UNITED STATES PATENT AND TRADEMARK OFFICE

Office Action Summary

09/817,124

SUDO ET AL.

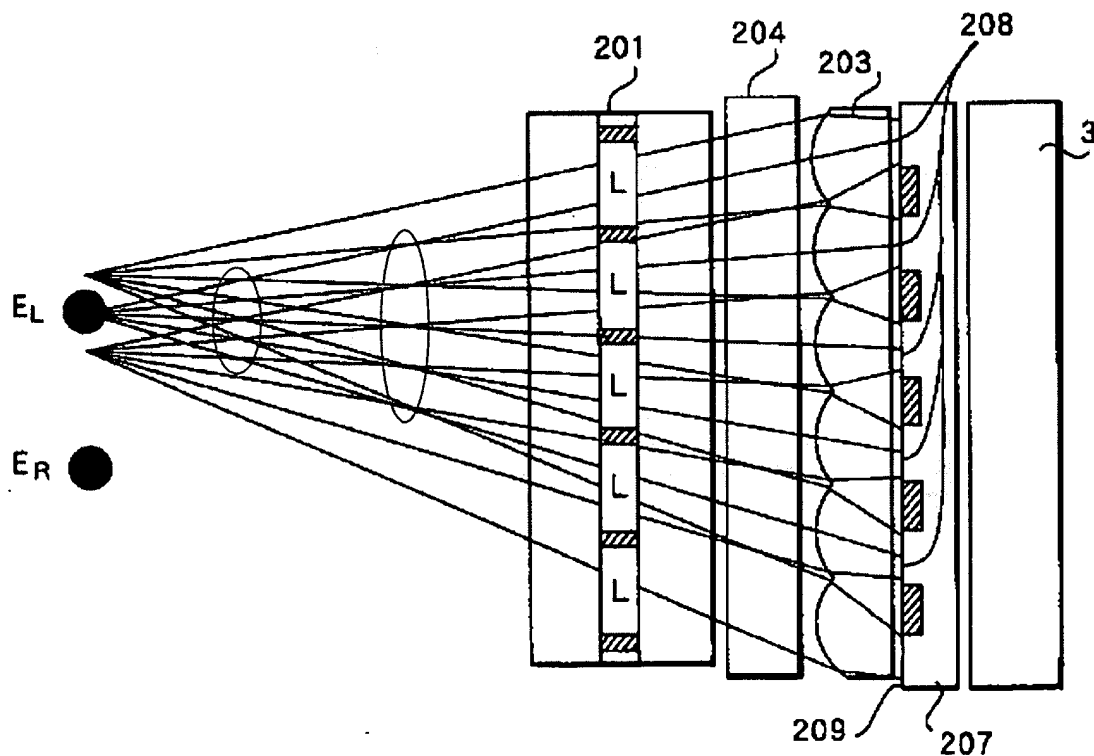
Osaka et al. teaches a plurality of rays are directed (irradiated) by a stereoscopic image display device at an observer's one eye for the display of a stereoscope 3D image (column 23, lines 16-45), wherein said plurality of rays carrying image data intersect at a plurality of locations in air (Fig. 2; Fig. 22A-B) –

see the figure above, wherein an example of said intersections, between elements E_L and 201, are circled to indicate their respective locations in space.
